RESPONSES TO PEER REVIEW REPORT MOUNT OWEN CONTINUED OPERATIONS PROJECT

The DP&E then commissioned a peer review of the AQIA and RTS report. This peer review was submitted to the DP&E on 30 October 2015 and provided to Pacific Environment for comment on 4 November 2015. A meeting was held at the DP&E on 10 November to discuss and clarify a number of issues raised by DP&E's reviewer. Following this meeting an amended peer review report was issued on 20 November which included revised comments and statements. This document is a response to that amended peer review report issued on 20 November 2015.

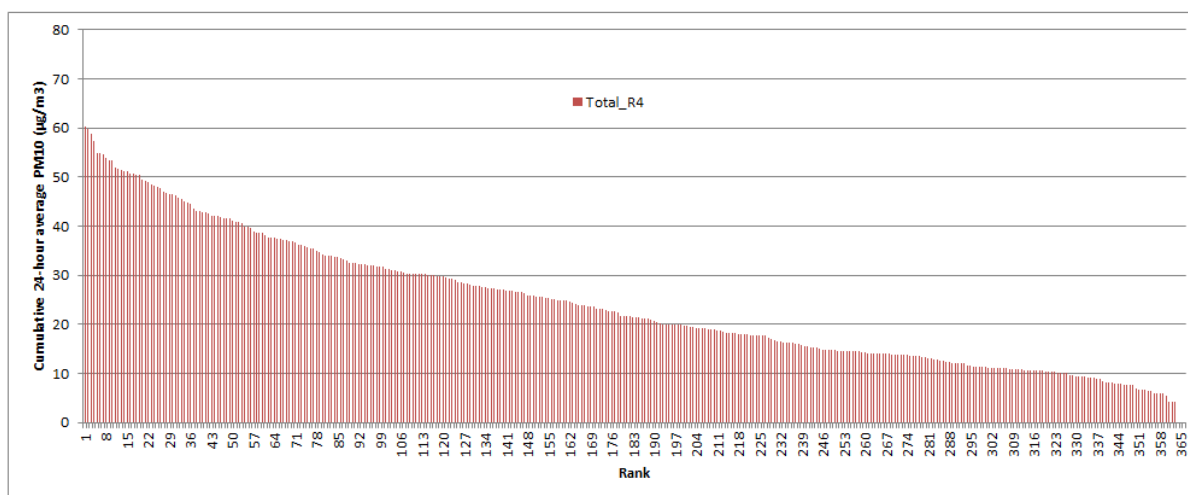
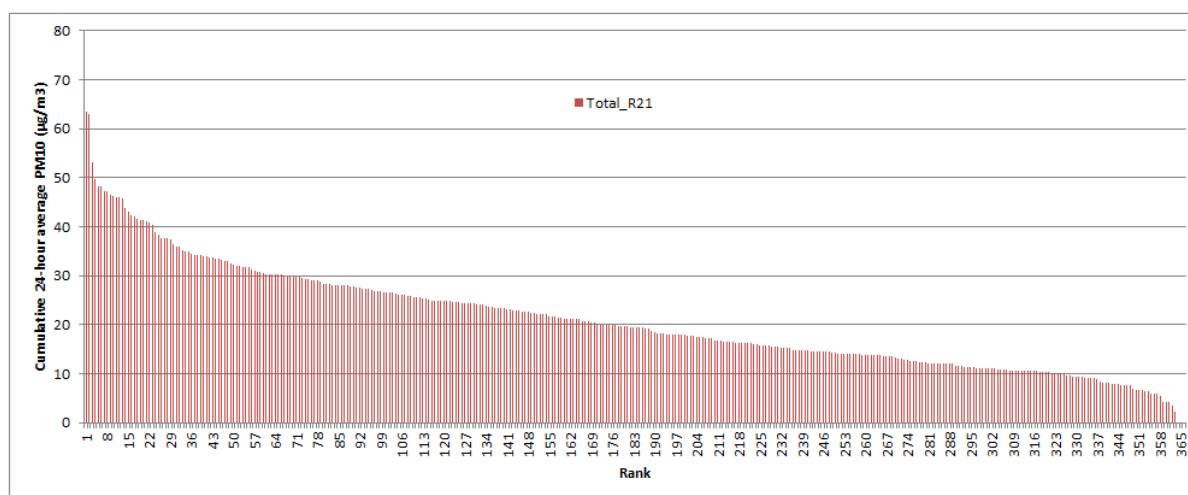
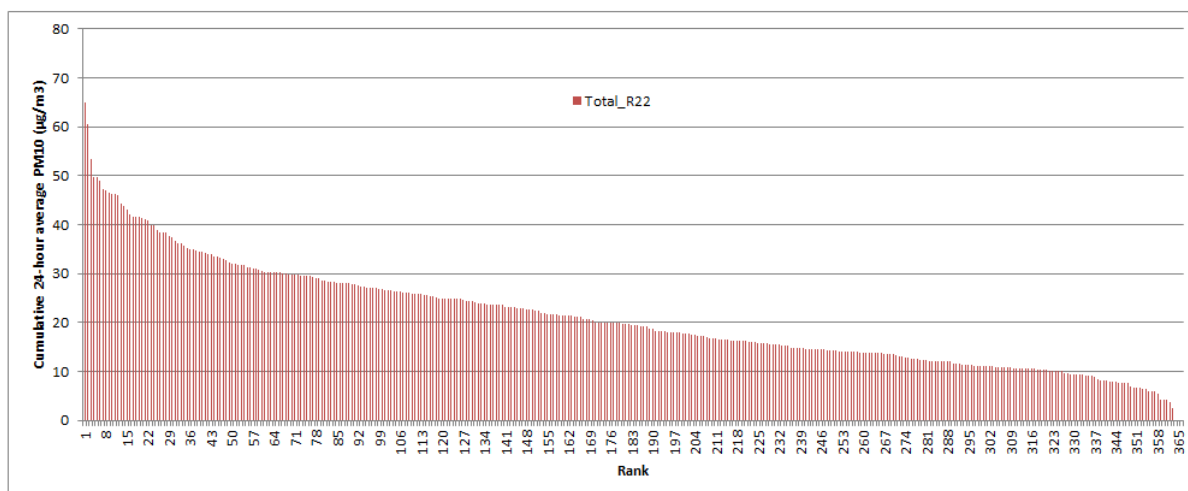
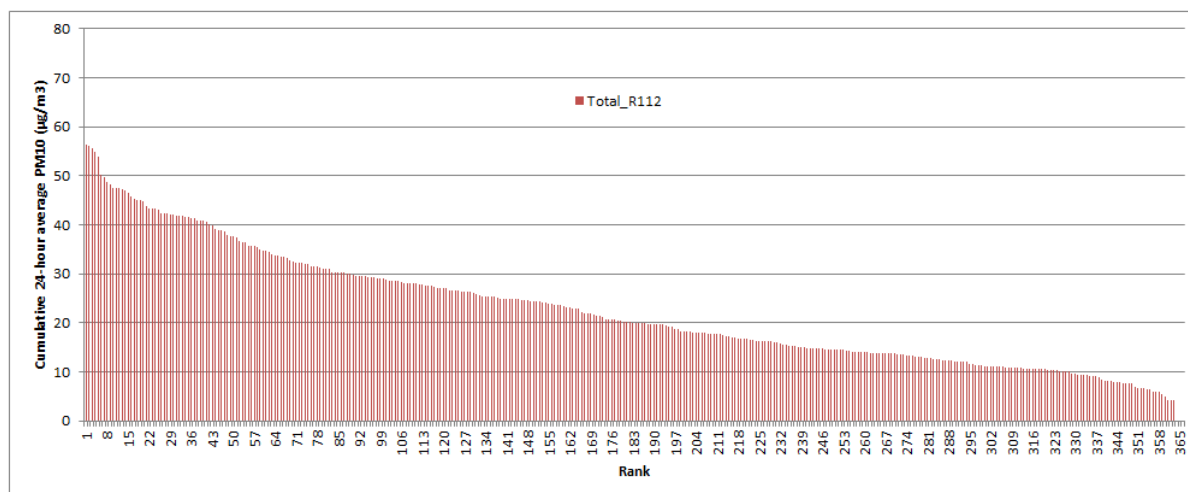
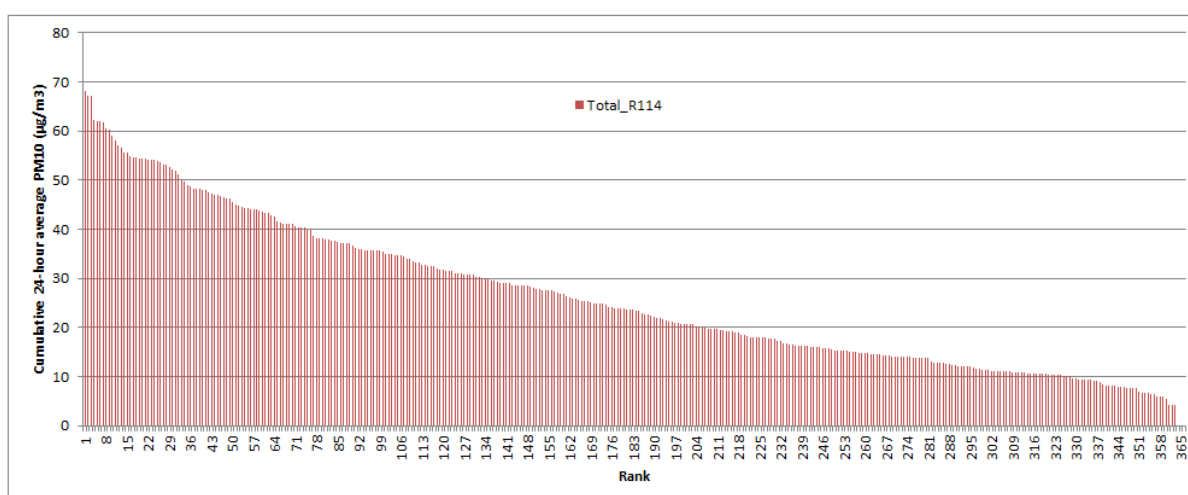
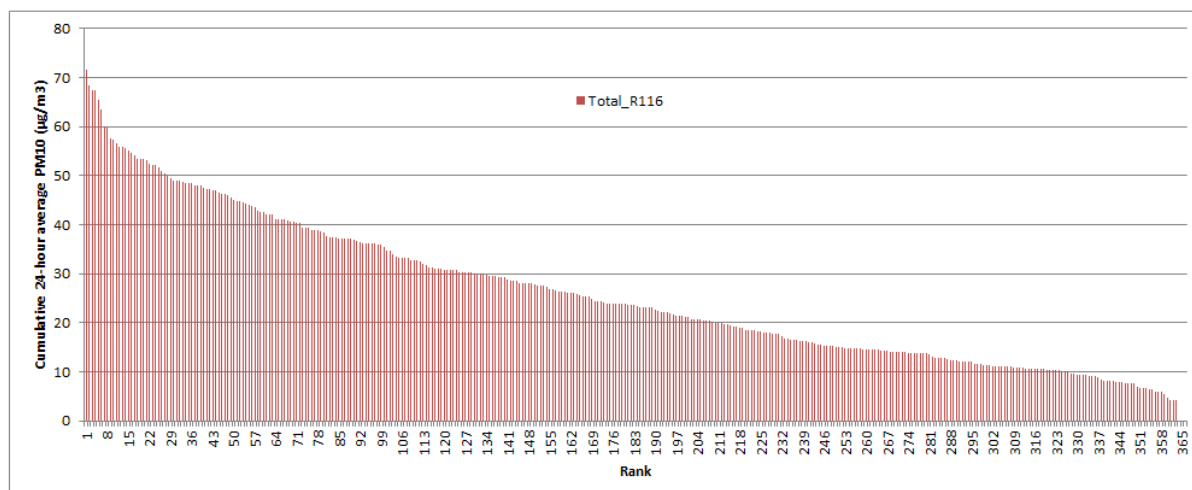
The second issue raised by the EPA and noted by the reviewer as requiring further work, concerns the 24-hour PM₁₀ cumulative assessment. The EPA was concerned that the contemporaneous tables presented in the RTS report had not been extended sufficiently to capture all potential days of exceedance.

Both the EPA and the reviewer have asked for this information which is now presented in the following graphs. Time series were extracted for 24-hour average PM₁₀ concentrations at the same six residences as presented in the RTS report. A predicted concentration for each day of the year at each residence was then added to the monitored value on that day, using data from the SX9 monitor.

Figure 1 to Figure 6 present the total cumulative (modelled plus measured) 24-hour average PM₁₀ concentration for the entire year (Year 10 mine plan). As predicted using both the probabilistic (Monte Carlo) and contemporaneous methods, there are anticipated to be exceedances of the cumulative 24-hour average PM₁₀ criterion at these properties. However, as noted in the DP&E's Voluntary Land Acquisition and Mitigation Policy, this is not an acquisition criterion for cumulative impact as the reviewer suggests, but relates to the Project only (incremental) increase.

Table 1 below, summarises the number of days predicted to exceed at these six residences in the AQIA using the Monte Carlo method, and the corresponding number of days using the Approved Methods (extended to a full year). R21, R22 and R112 show the same number of estimated days for both methods. R4, R114 and R116 already showed more than 5 potential exceedances per year as presented in the AQIA and so the outcomes of the assessment are unchanged.

Figure 7: Location of CALMET extract between the Project and residences to the southeast

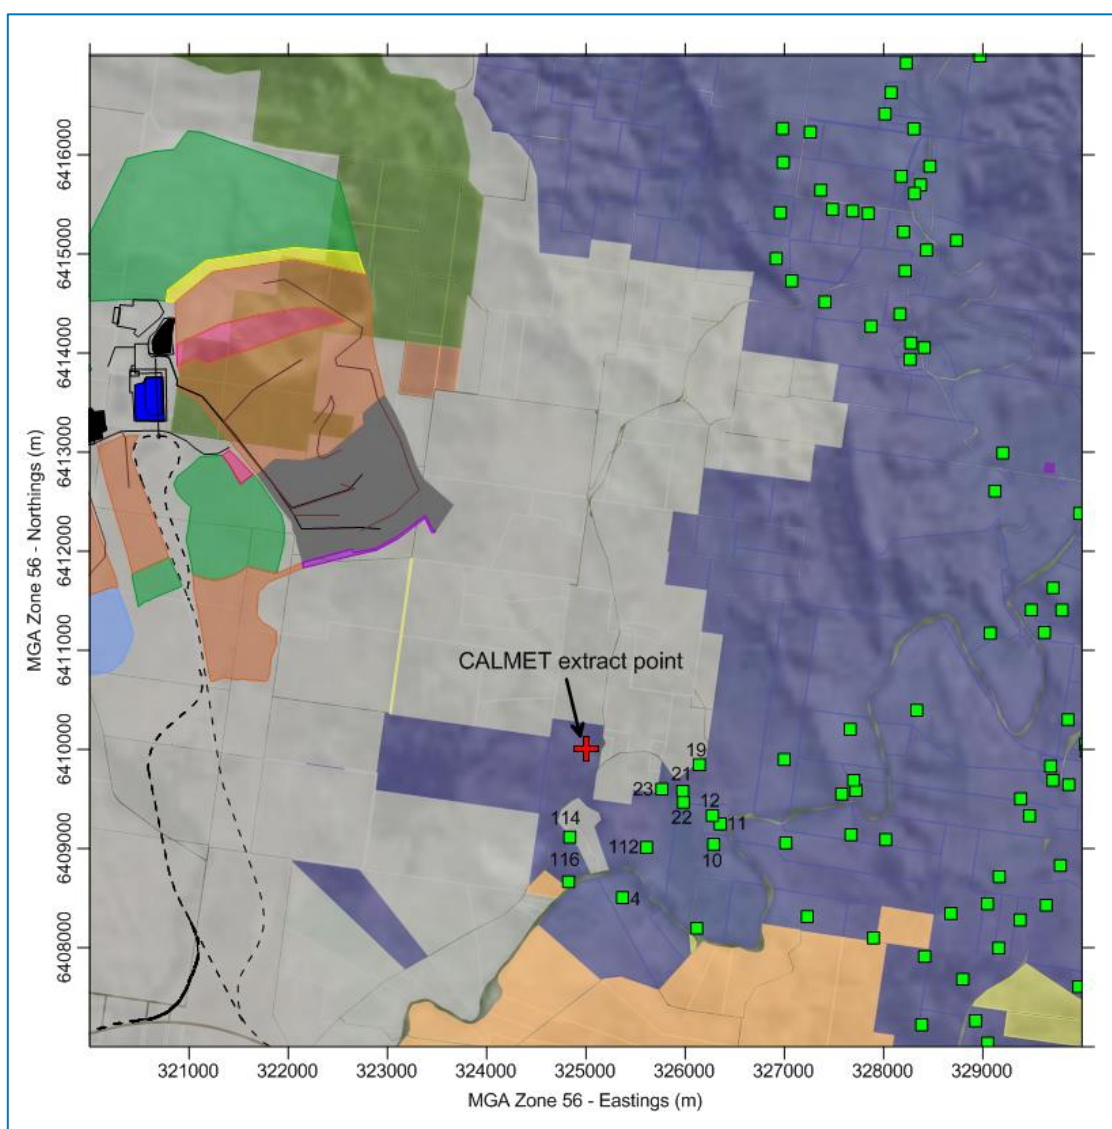
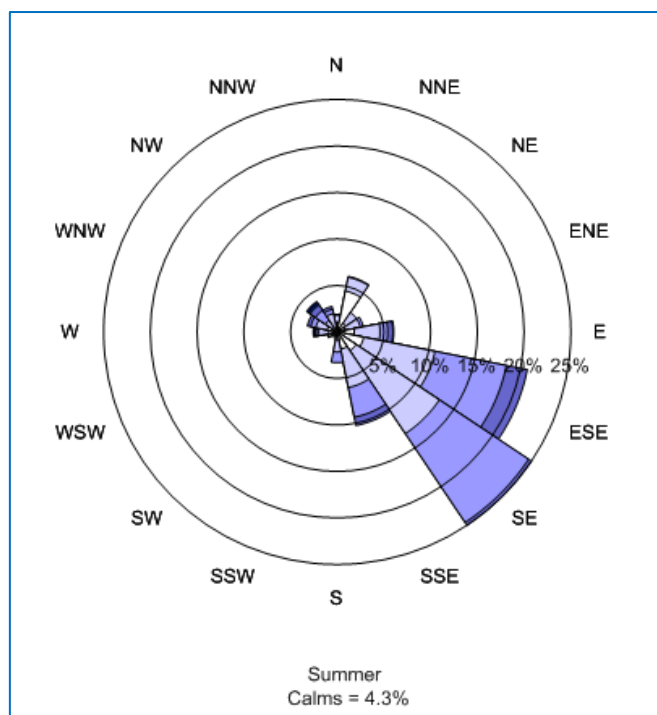
In the meeting at DP&E on 10 November 2015, the reviewer noted the apparent absence of winds from the northwest during summer at SX8 in the modelling year (Figure 5.2). The reviewer was concerned that the absence of northwesterly winds during summer in the model may result in an underestimate of impacts to residences to the southeast of the Project during the hot summer months.

It was brought to the reviewer's attention that these winds were represented at the SX13 site and the data from both of these stations were used in the CALMET model, as well as other inputs such as local terrain and landuse, to produce a three-dimensional meteorological file with predicted meteorological parameters at all points on the modelling grid. In other words, the fact that these northwesterly winds

are not represented in the summer of the modelling year at SX8, does not necessarily mean that they are not represented in the modelled summer conditions near the residences to the southeast. It does also not necessarily mean that northwesterlies did not occur at all in the modelling year as the windroses from both meteorological stations show these winds to be present in other seasons.

The reviewer agreed at the meeting that if a meteorological file could be extracted at a representative point near the residences to the southeast and it showed a northwest contribution during summer, then that would satisfy his concerns and this issue would be considered closed. This has been done and an extract from the meteorological CALMET modelling file was made at the location shown in **Figure 7**. The summer windrose for that site is presented in **Figure 8** and shows winds from the northwest towards the residences in the southeast.

Figure 11: Calibration values in the zoomed in area to the southeast of the Project

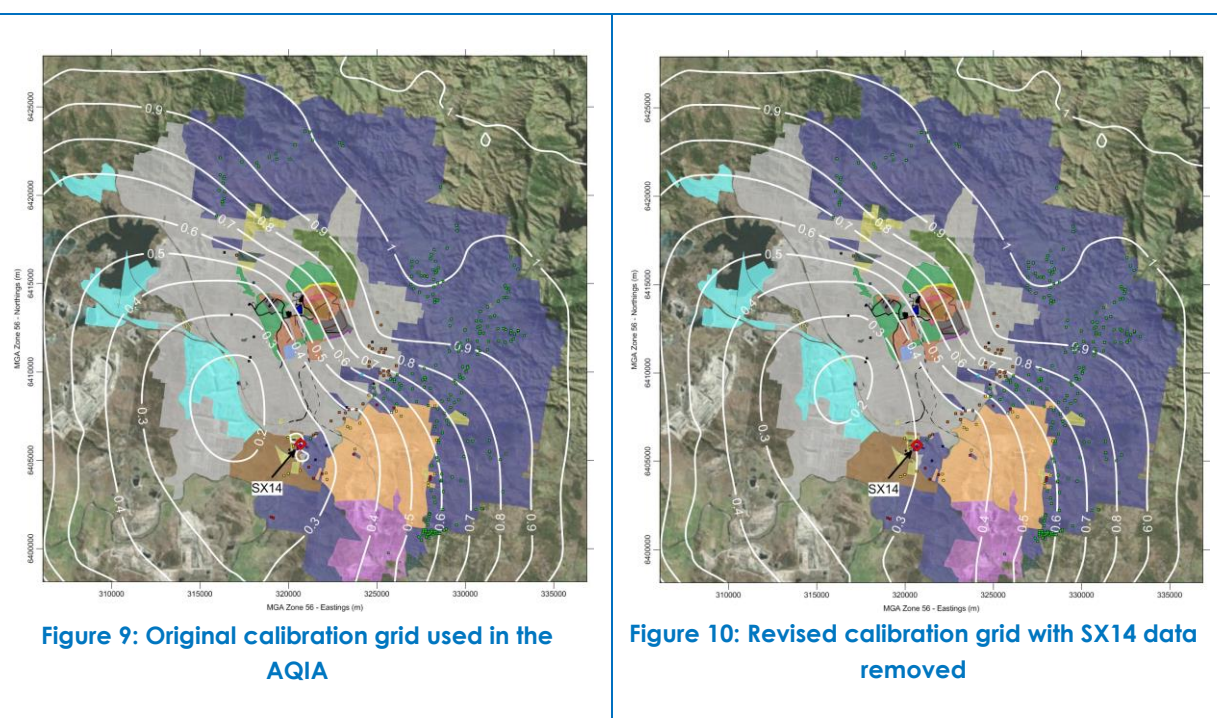
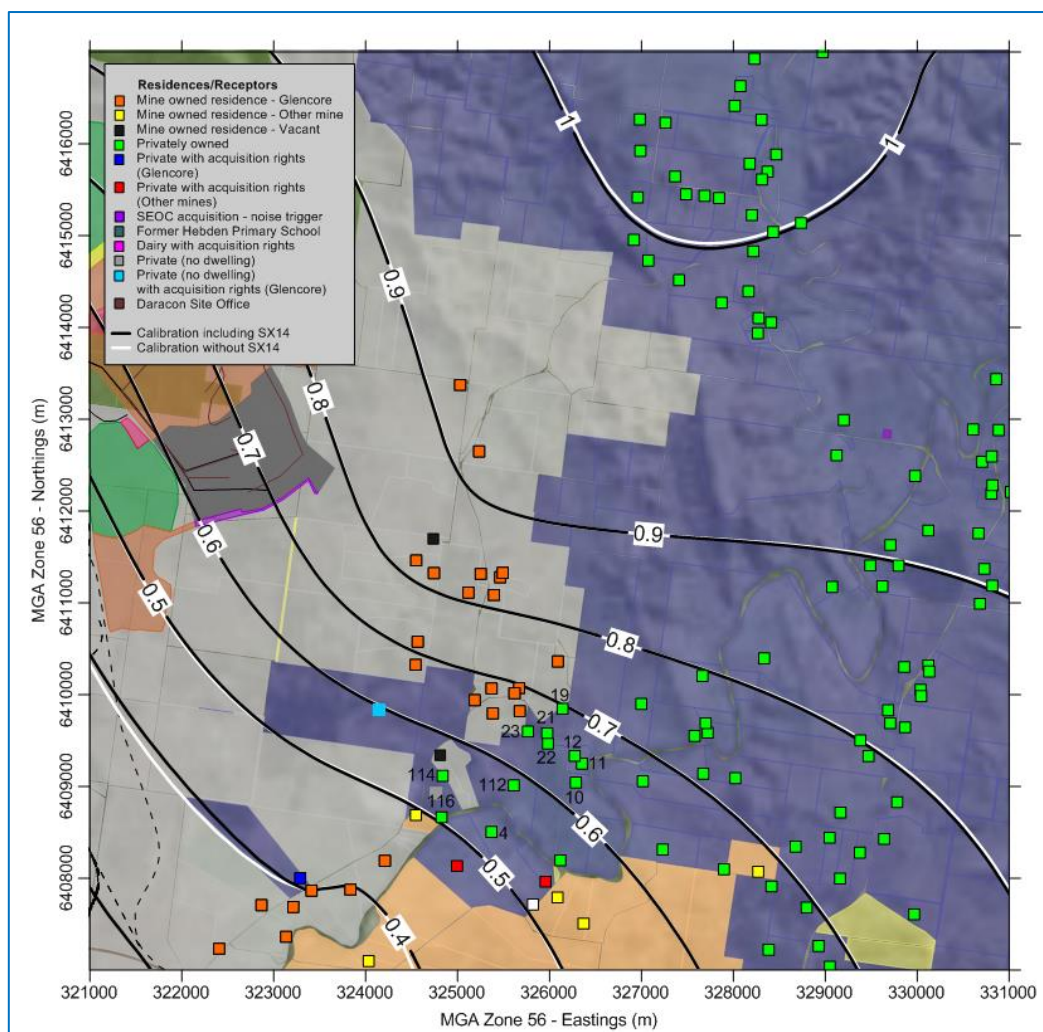
Individual monitors will be subject to local activities as well as regional events. Camberwell has been surrounded by various mining activities in recent years and air quality levels in the village are likely to fluctuate accordingly. The OEH monitor at Camberwell located close to SX14, also recorded a low annual average PM₁₀ level for the same period (modelling year 2011-2012).

However, a sensitivity analysis has been carried out by removing SX14 from the determination of the calibration grid. **Figure 9** below shows the calibration grid as used in the AQIA and **Figure 10** shows the same grid with the SX14 monitoring data removed from the analysis. This comparison shows that there is very little difference between the two plots except for the area immediately surrounding the SX14 monitor in Camberwell.

It is important to note that removing these data from the analysis does not make any material difference to the calibration values in the main area of significance to the southeast of the Project.

Figure 11 presents a zoomed in plot of this area to the southeast showing calibration contours with and without SX14. It shows that the model is performing reasonably well at all of the privately owned receptors (shown in green), with calibration factors at those residences of between 0.5 – 1.

Figure 18: Original TSP emission distribution using onsite in pit moisture measurements

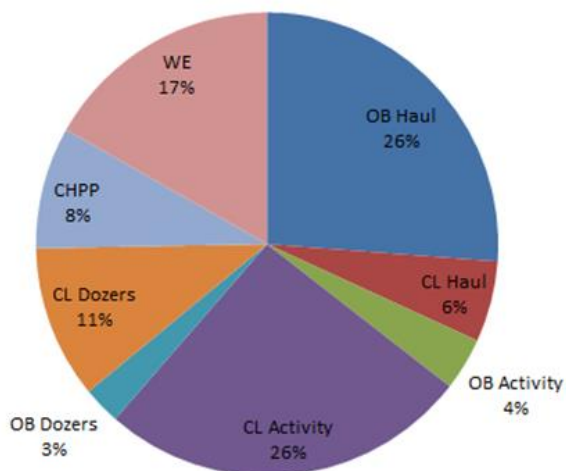
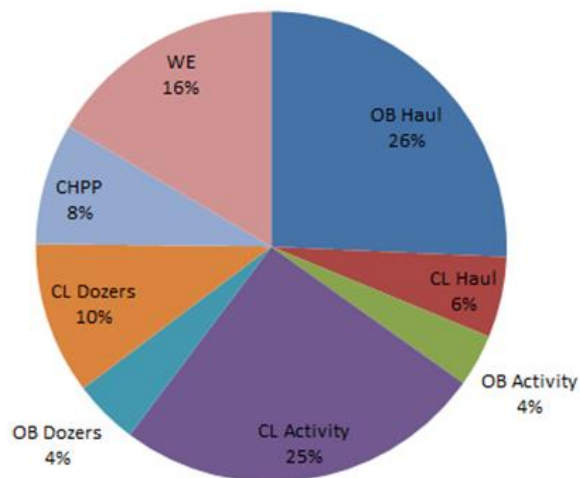
The reviewer's concern with the emission calculations used in the assessment is the use of on-site silt and moisture content measurements and whether this skews the inventory. At the meeting on 10 November the reviewer was mainly concerned about the difference in moisture content between the in pit and out of pit overburden moisture content. In particular, it was thought that the use of the measured 'inactive overburden' moisture and silt data would lead to a much smaller proportion of emissions from dozers. The 'inactive overburden' data is only used in the modelled emissions from dozers working on overburden out-of-pit. The modelled emissions from handling overburden in-pit and the unloading of overburden trucks use the lower moisture overburden data which were obtained from the testing of samples of in-pit overburden.

The emissions for Year 1 were recalculated applying the lower moisture content of the in-pit overburden to the out-of-pit activities. This increased the overall TSP levels in the modelled Years 1, 5 and 10 by 0.3%, 0.3% and 0.4%, respectively and would make no material difference to the outcomes of the assessment. The distributions of TSP by activity for the original inventory and the reduced moisture inventory are shown below in **Figure 18** and **Figure 19** respectively. The updated calculations do not show any significant change to the distribution for TSP emissions and would not result in any material difference to the outcomes of the assessment.
